Arts Building Seismic Correction & Renewal
Project No. FM090010L/988720

Addendum No. 3

July 14, 2010

ADDENDUM NUMBER 3

**BASEMENT
 DEMOLITION RCP**

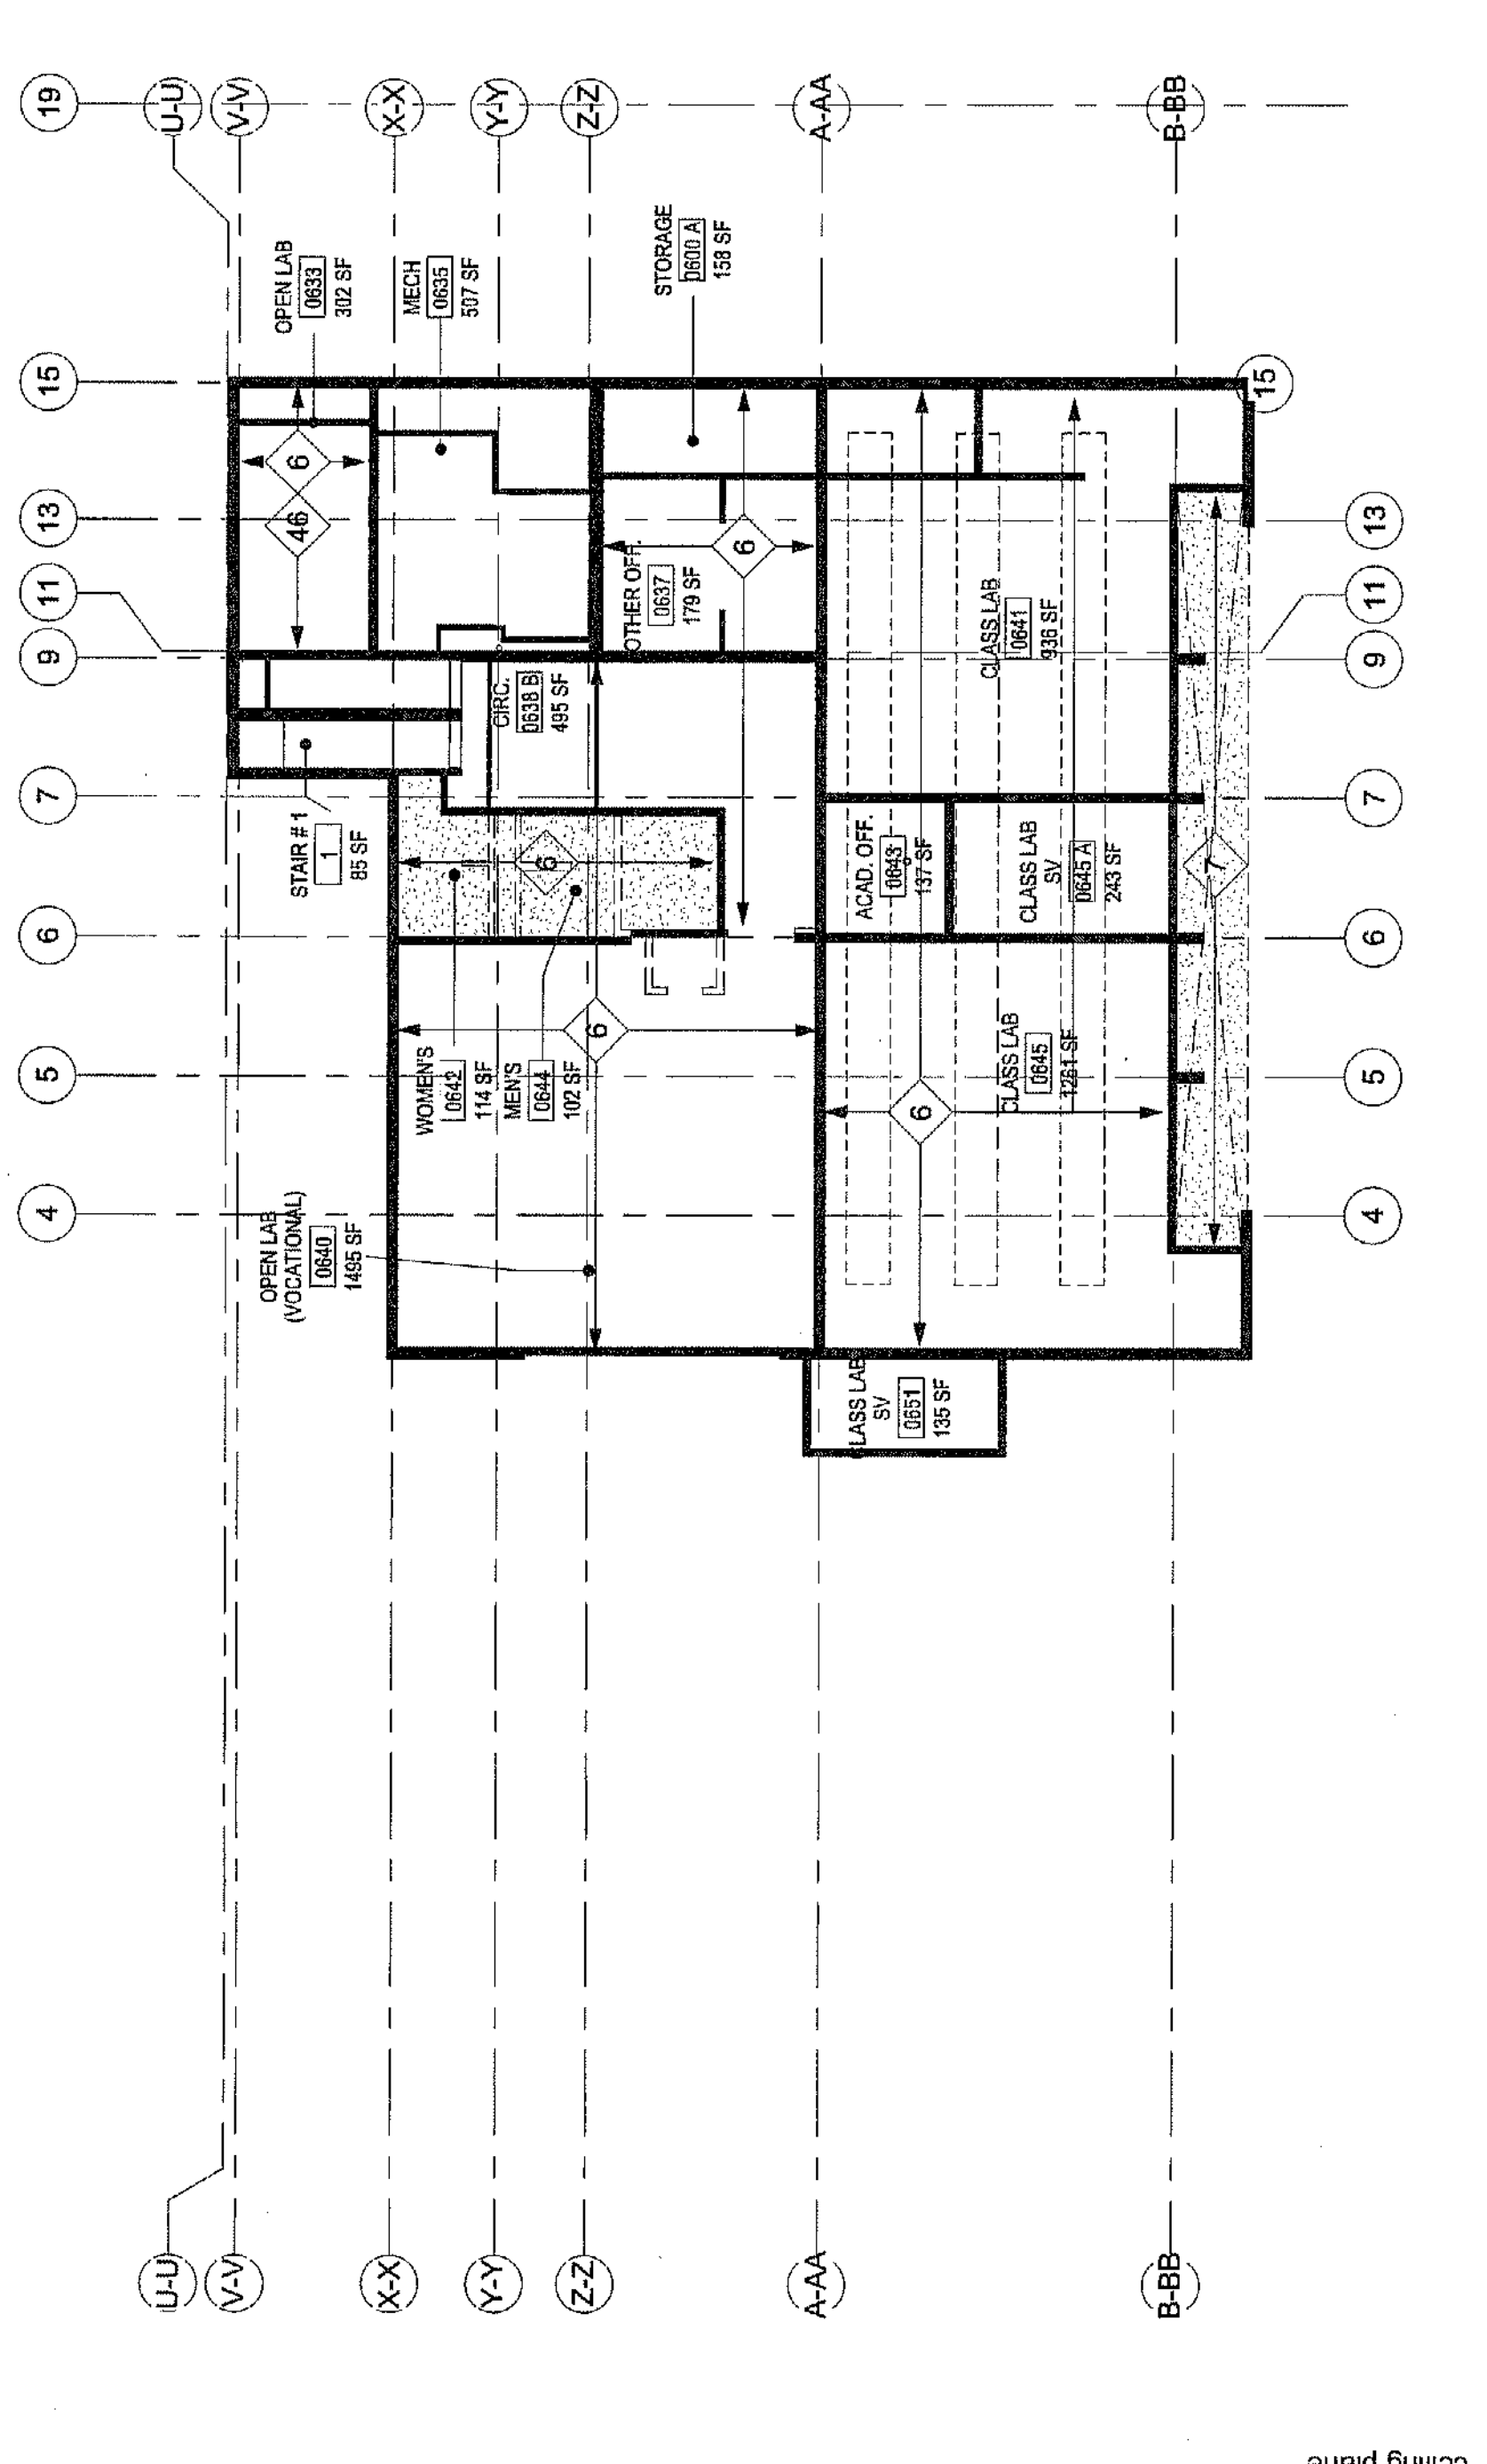
8. DRAWING NO. A6.01, BASEMNET DEMOLITON RCP **Replace** in its entirety with attached drawing A6.01, dated 7/8/2010. DEMO SHEET NOTES 4 & 5 **Add** the following;
- “NOTE 4. NON-HAZ INTERIOR DEMOLITION SHALL BE DONE IN A CLASS II NEGATIVE PRESSURE ENCLOSURE (NPE) AS DEFINED BY CCR TITLE 8 SECTION 1529. NON ASBESTOS WORK SHALL BE COMPLETED PRIOR TO ASBESTOS REMOVAL. IF ASBESTOS CONTAINING OR CONTAMINATED MATERIAL IS TO BE DISTURBED; THAT PORTION OF THE WORK SHALL BE POSTPONED UNTIL ASBESTOS ABATEMENT PORTION OF THE WORK. SEE SPECIFICATION SECTIONS 02080, 02081 AND 02082.
